**ADERRIG PHASE 2,  
ADAMSTOWN,**

**RESPONSE TO  
CLARIFICATION OF FURTHER  
INFORMATION- SDZ21A/0014**

**ARCHITECTURAL  
COMMENTS**

**JANUARY 2022**

Typical parking vs tree arrangement on Linear Park Road (Site layout Drawing extract)

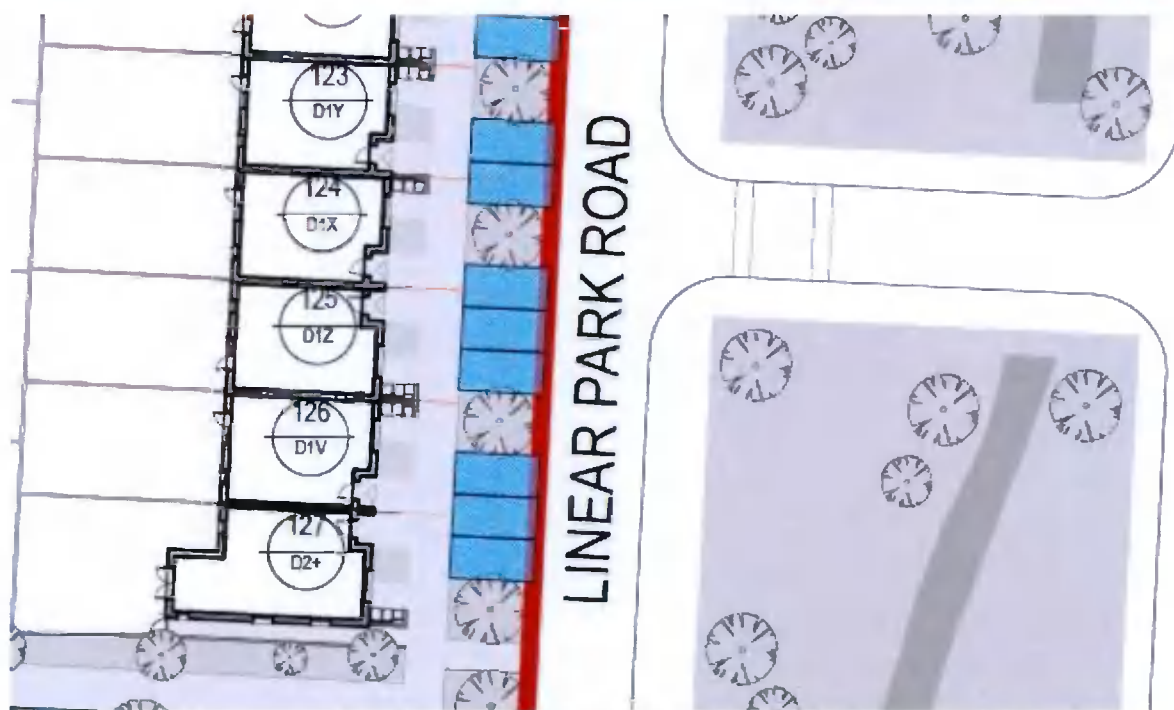
**(1) The provision of Street trees along Linear Park Road (Avenue), integral to the street, has not been achieved and the response to the AI request is not satisfactory. In order to achieve street trees that are integral to the street, the applicant is requested to provide the following:**

- (a) Additional space for tree planting integral to the street;**
- (b) Move the footpath to the rear of the car parking so street trees can be integral to the street;**
- (c) Provide parallel parking along Linear Park Road (Avenue) with integrated street trees every two or three car parking spaces.**

The parking and tree planting arrangements along the Linear Park Road (Avenue) on the eastern site boundary have been reconfigured so that all parking on this road is now located adjacent to the road with the footpath located between the parking bays and the dwellings. The parking bays have been reconfigured to provide 2 to 3 parking spaces (with a maximum of 3 parking spaces) between landscaped islands for the provision of street trees along the length of the road. Each tree planting zone will be between 3.5m and 4.4m wide depending on location. The parking bays are configured in a perpendicular rather than parallel format in order to provide adequate parking to the 4 bed dwellings along Linear Park Road. Section 1.5.2 of the AD SG facilitates a flexible approach and allows SDCC to grant permission for design solutions other than those presented, as long as the approach accords with the objectives of the document 'particularly where they represent up-to-date design philosophies and/or are more environmentally sustainable solutions', it was deemed acceptable to the Council at the meeting on the 14/1/2022. Please refer to Atkins note which outlines the rationale for perpendicular parking along this Avenue and adherence with DMURS.

We respectfully contend that the combination of the reduced dominance of parking along the Linear Park Road and the introduction of street trees at approximately 11m centres adjacent to the carriageway will successfully address the issues raised and will create an appropriate Avenue environment in accordance with the general intention of the SDZ and the Adamstown Street Design Guide.

Adamstown Way – Parking now proposed (5 parking space – red dots) ( accessible spaces hatched green)

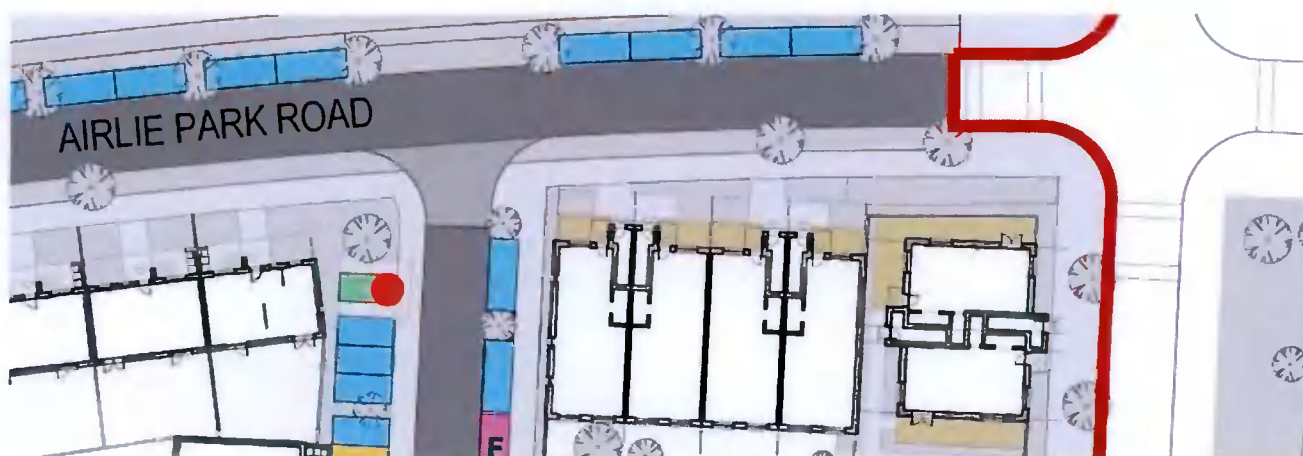
In the RFI dated 28 July 2021 the Council had queried the absence of parking along the western end of Adamstown Way. It was previously believed by the clients Design Team that the level of the existing live services along the line of the potential parking zone precluded the delivery of spaces in this area. However, late in Q4 of 2021 site investigations established that the services are in fact located at a depth which would not hinder the delivery of parking in this area provided that the visibility splays for vehicles at the adjoining junctions are not affected. The provision of a limited number of parking spaces along Adamstown Way also supports the ground floor duplex units in this area which are all accessed from Adamstown Way and must otherwise park at Home Zone 3 or Side Street 4. On this basis two of the parking spaces at the eastern end of Adamstown Way have been combined to provide an accessible parking space and four spaces (including an accessible parking space) are proposed at the western end. The spaces are highlighted on the diagrams below for clarity.

*Parking space changed at north end Side Street 1 denoted by red dot (accessible spaces hatched green)  
(Parking Strategy Drawing extract)*

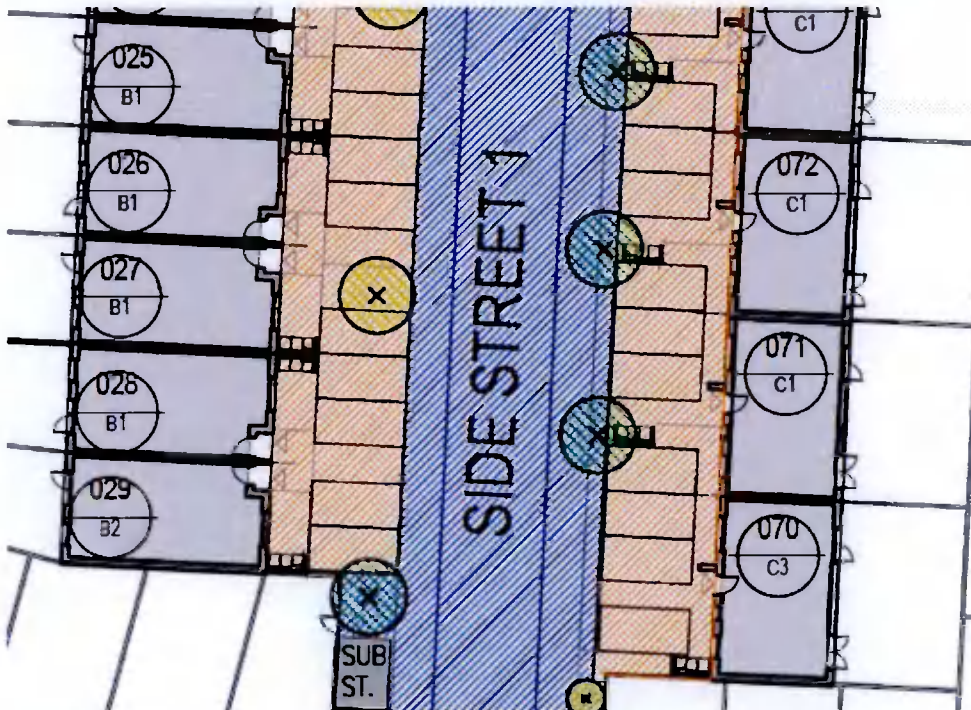
A further parking space has been changed to an accessible parking space at the northern end of Side Street 1 to provide direct access to the Duplex units on the eastern end of Airlie Park Road and to the four storey Type G duplex block at the junction of Airlie Park Road and the Linear Park Road.  
(highlighted on the drawing extract below)

Parking on east side of Side Street 1 & 4 now under OMC control (Parking Strategy Drawing extract)

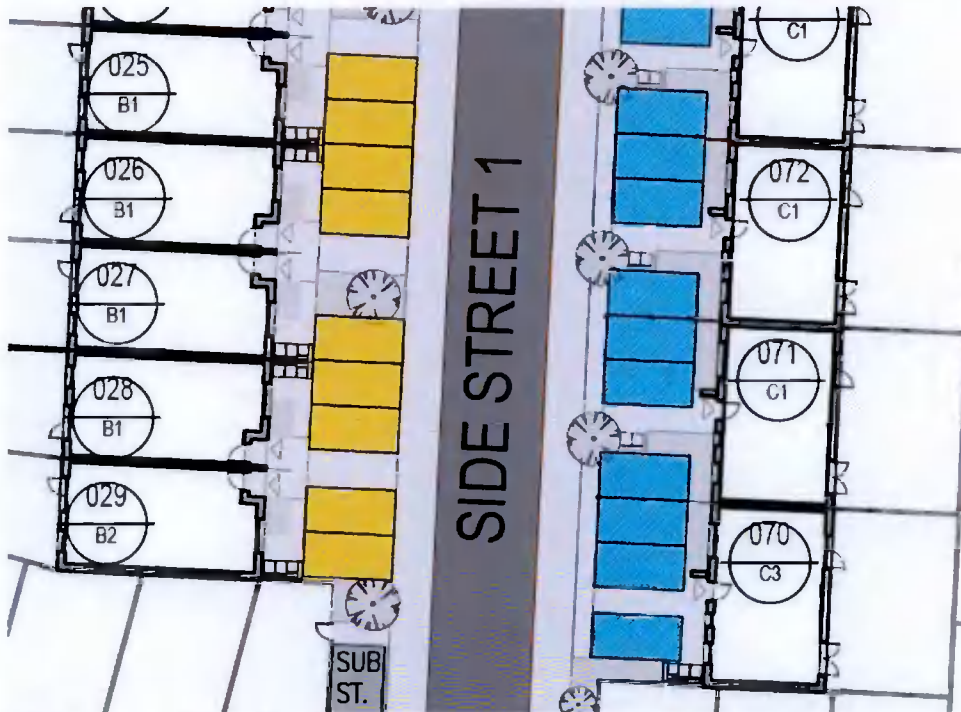
(2) The submitted parking strategy, which indicates 'off-curtilage' spaces within the curtilage of dwellings on side streets 1 and 4, is considered to be inappropriate and it is unclear how this can actually operate on the ground. The applicant is requested to provide a revised parking strategy which addresses this matter, the parking should either be all off-curtilage or all on-curtilage (unless it can be clearly demonstrated how both on and off can operate alongside each other).

All of the parking spaces on the eastern side of Side Streets 1 and 4 are now shown off curtilage and under the control of the Owners Management Company to address the Councils concerns.
